City of Albuquerque

RE: CONCEPTUAL DRAINAGE PLAN FOR UNIVERSITY CENTER PARCEL 10 & 11
PHASE I (L-15/D31B) ENGINEER'S STAMP DATED FEBRUARY 5, 1990

TYPICAL SECTION ACCESS RAMP CHANNEL
NOT TO SCALE

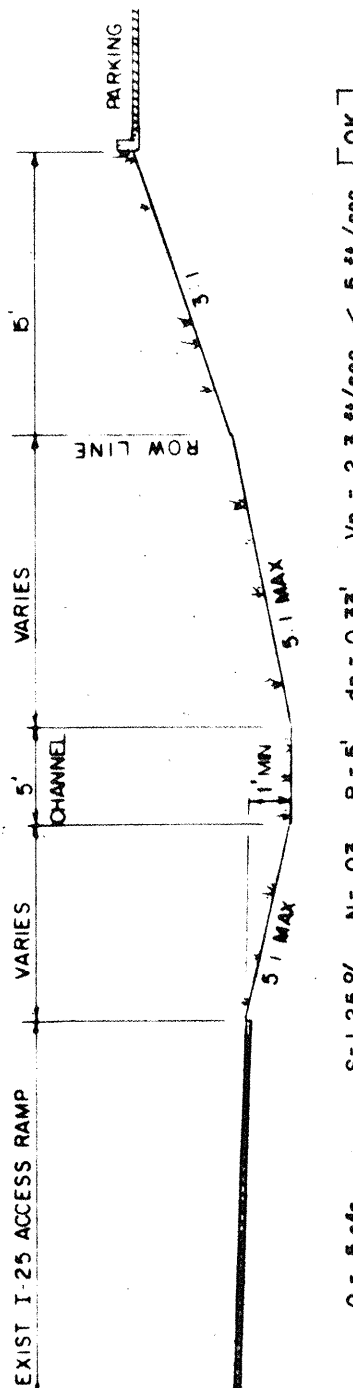
1. How will the 5.0 cfs of offsite flows be conveyed onto the access ramp? More detail needed.
2. Six notes and sign-off block must be included within the plan drawing as a Special Order #19 format.
3. Top soil permit must be coordinated with Environmental Health Department.
4. Will the ACS benchmark serve as the project T.B.M.?
5. More top of curb and flow line elevations on the plan drawing.
6. Top of curb and flow line elevation must be shown on Stadium Boulevard, SE.
7. Please identify what method you used to compute your volumes.
